Application No.: 10/020605

Docket No.: 10010107-1 47429-00021USPT

REMARKS

AMENDMENTS TO THE DRAWINGS

FIG. 2

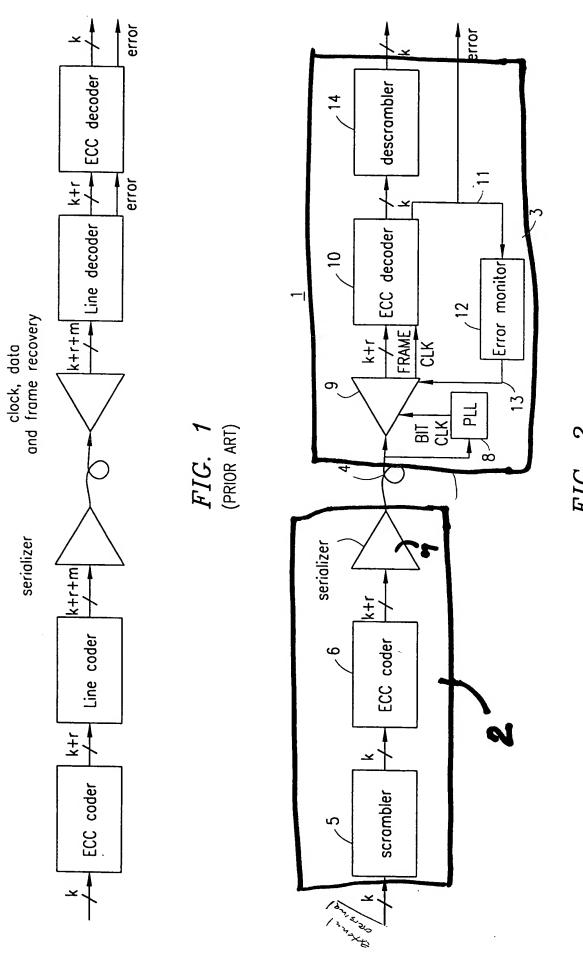
The Drawings were objected to for failing to comply with 37 C.F.R. § 1.84(p)(5) because

they did not include the reference characters 2 and 7 which are discussed in the specification as

indicated by the Examiner. Applicant is providing an amended replacement drawing sheet,

clearly labeled "Replacement Sheet", such that, elements 2 and 7 are clearly indicated as

supported in the specification. Applicant respectfully requests that the drawing objection be

The attached sheet(s) of drawings includes changes to Figure 2.
